Intel® Pentium® 4 Processor in 478-pin Package and Intel® 845E Chipset Platform for DDR

Design Guide Update

Document Number: 252737-002

Figure 11-1. Clock Topology

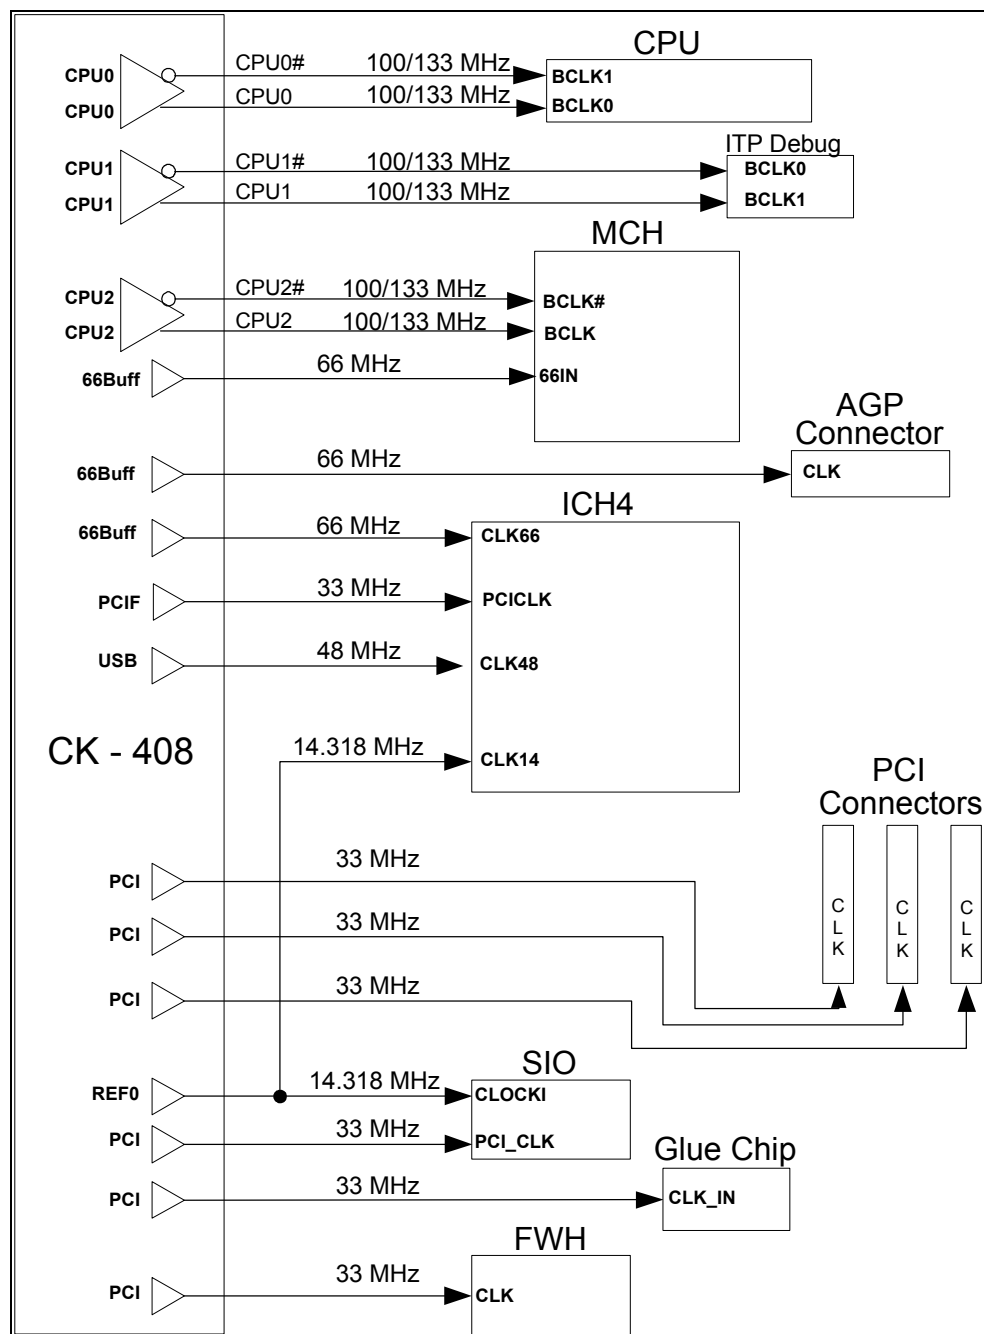
(2) Replace Figure 11-1, Clock Topology, with the following new figure:
